**Correspondence Between  
Staff and Applicant  
Approval Letter**

**REPORT TITLE:** District at the Quarter Traffic Impact Mitigation Analysis

**CASE #:** 8-ZN-2016

Re: District at the Quarter: 2<sup>nd</sup> Review Comment Responses and Requested Materials.  
Case #: 3-GP-2016 & 8-ZN-2016:  
Location: Northeast Corner of Greenway-Hayden Loop & 73<sup>rd</sup> Street

### Site Plan

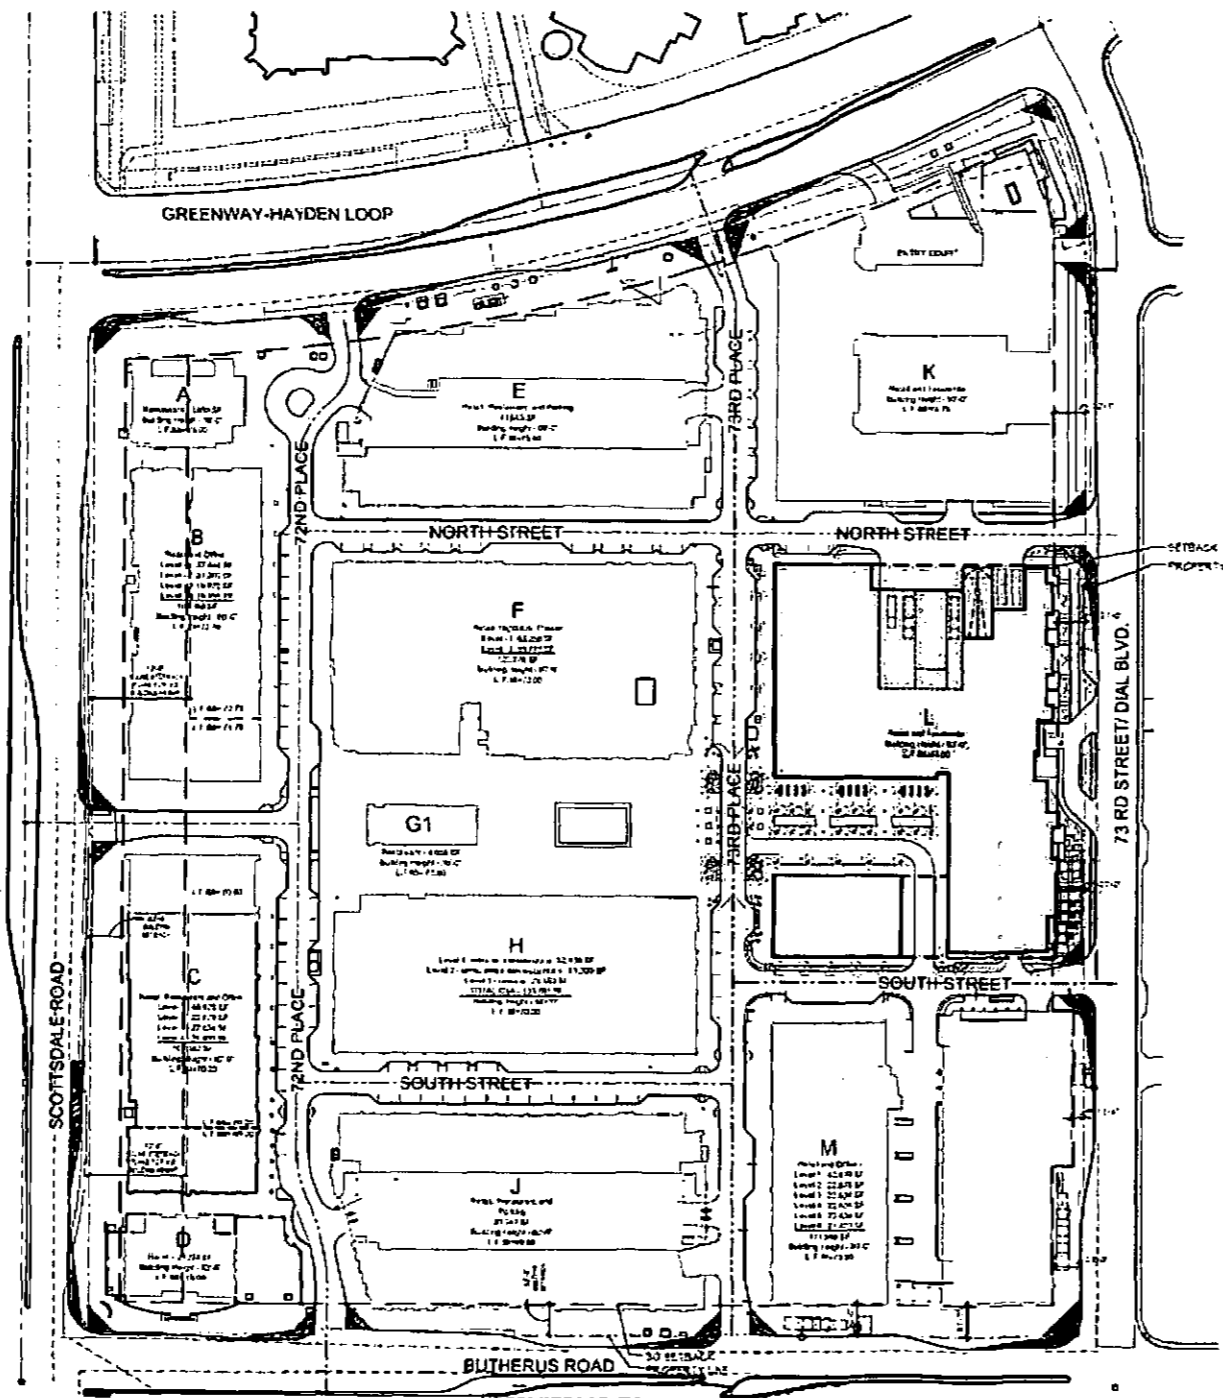
1. Please provide a site plan that complies with the Plan & Report Requirements for Development Applications. There will be comments regarding the site plan after it has been received and reviewed by staff. Please refer to Zoning Ordinance Section 1.303.

- a. Revise the project data to indicate bicycle parking - required, provided, show calculations. Please refer to Zoning Ordinance Section 9.103.
  - b. Revise the project data to indicate private open space per unit type - required, provided, show calculations - on the site plan. This shall be labeled as "Private Outdoor Living Space". Please clarify what the "Club" units are, as these do not appear to have any patio areas.
